**Panoche Energy Center  
Application for Certification  
Data Request Responses – Round 2  
06-AFC-5**

**January 31, 2007 Data Requests – Round 2**

**Panoche Energy Center**  
**Application for Certification**  
**Data Request Responses – Round 2**  
**06-AFC-5**

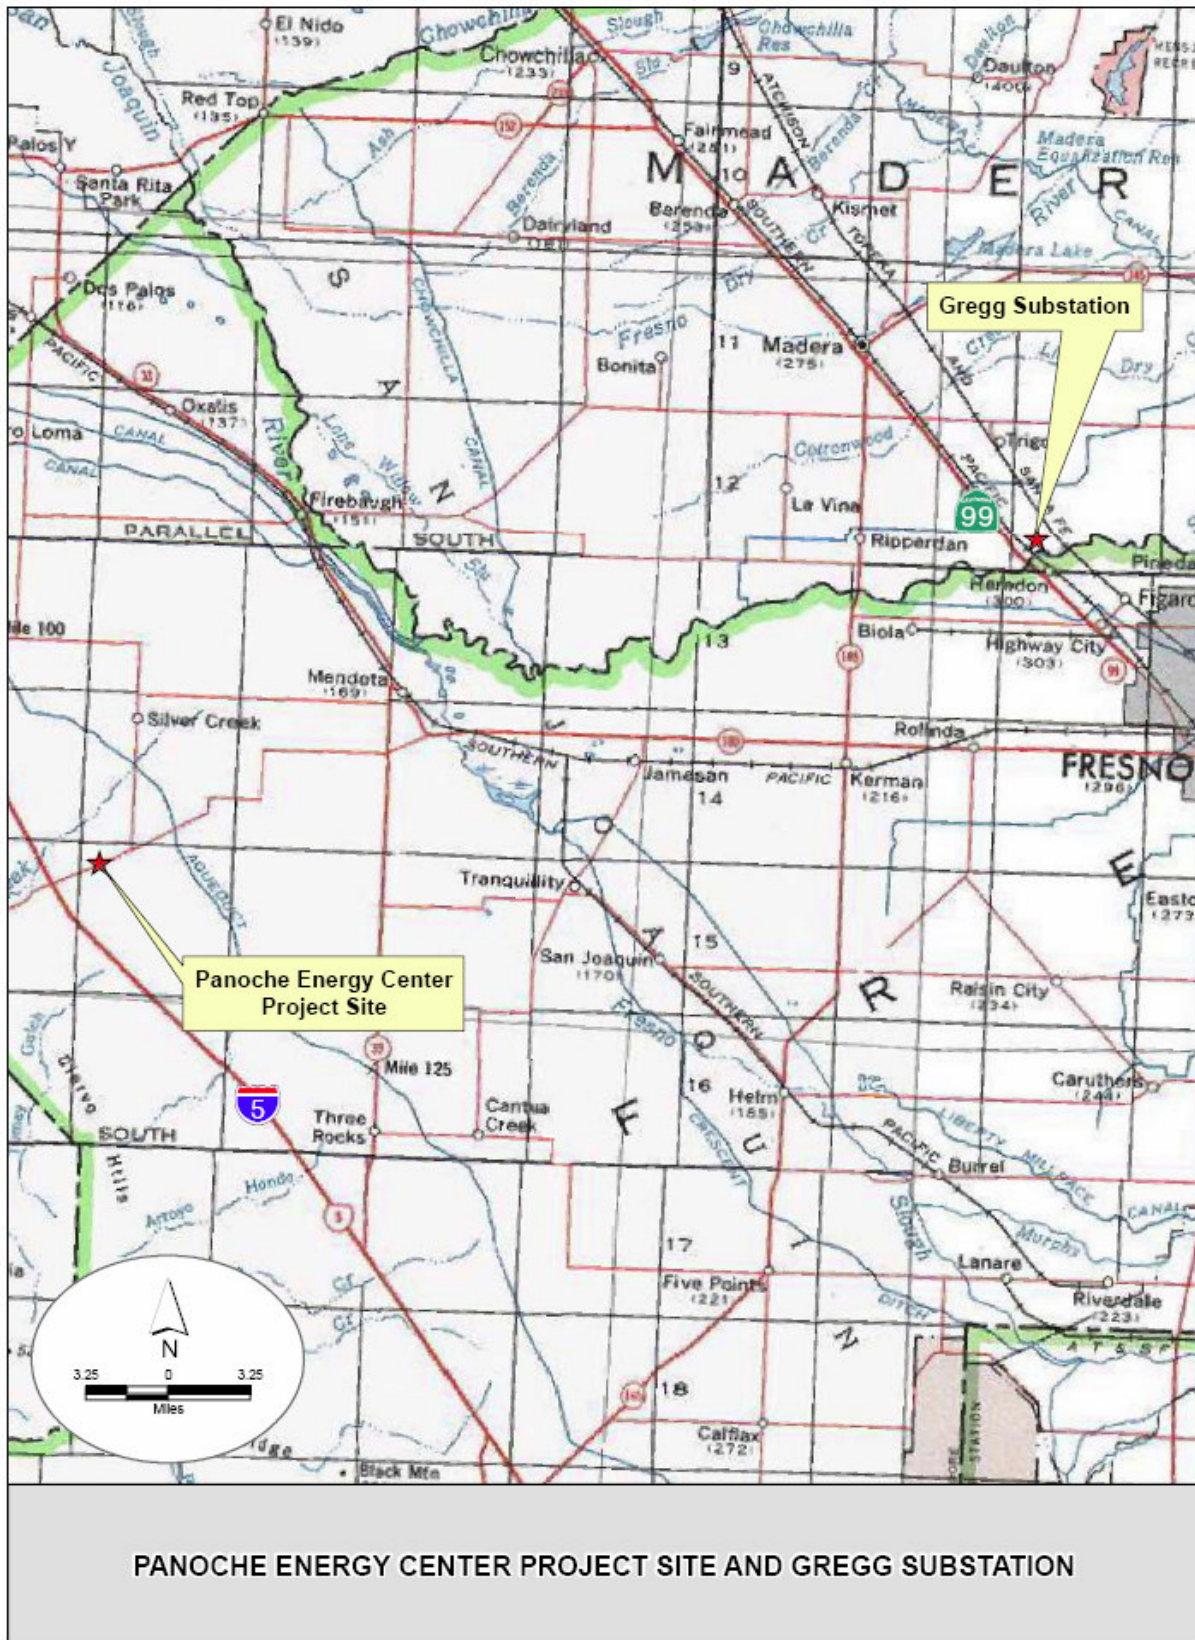
**Data Request 63 Rev:** Please provide a map showing the Wilson-Gregg 230 kV transmission line and the one-mile segment which would have to be reconductored. Also, please include on the map the substation which will be upgraded. Please use a scale which will allow staff to discern where the segment and the substation are located in relation to the PEC project.

Aerial and topographic maps showing the one-mile Wilson-Gregg 230 kV transmission line and Gregg substation are provided in the response to Data Request 61 as Figure 2 (study area) and Figure 3 (topographic features). Please note that the substation is the *developed feature* shaded light orange at the southern end of the one-mile transmission line segment.

A topographic map showing the location of the Gregg substation in relation to the PEC project is provided on the following page.

**Exhibit B**

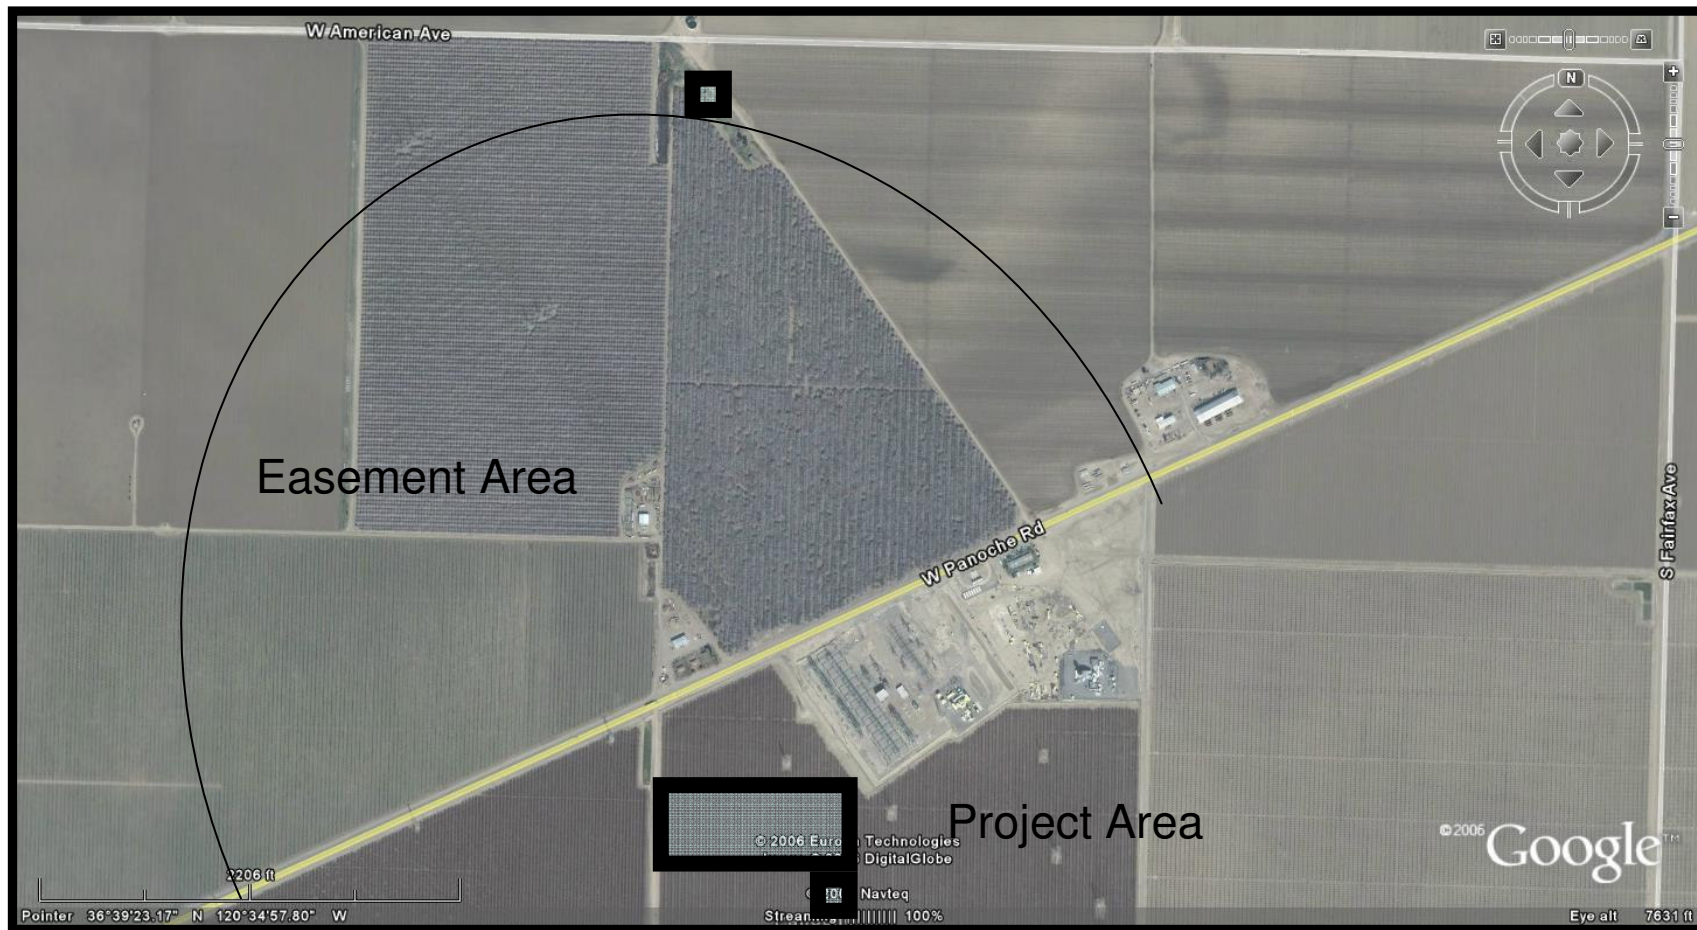
Please state if, in fact, the residence at ML2 will be relocated so that it is unaffected by the power plant noise. If the residence will be relocated, please provide the projected project noise level at the new location. Please also state if, as an alternative to relocating this residence, the Applicant will be able to demonstrate compliance with the 45 dBA Fresno County nighttime standard at ML2 (AFC Section 5.12.4.3.1). Please provide a list of possible additional mitigation measures that would be considered in demonstrating compliance with the above standard, should the residence remain at its existing location.

ML2 will be relocated to a location that is approximately 4000 feet north of the PEC site as shown on Exhibit B on the following page. Our current modeling effort shows that without further mitigation the nighttime noise level at the new location is estimated to be 48 dBA. Possible mitigation measures include sound barriers and noise abatement modifications to supplied equipment.
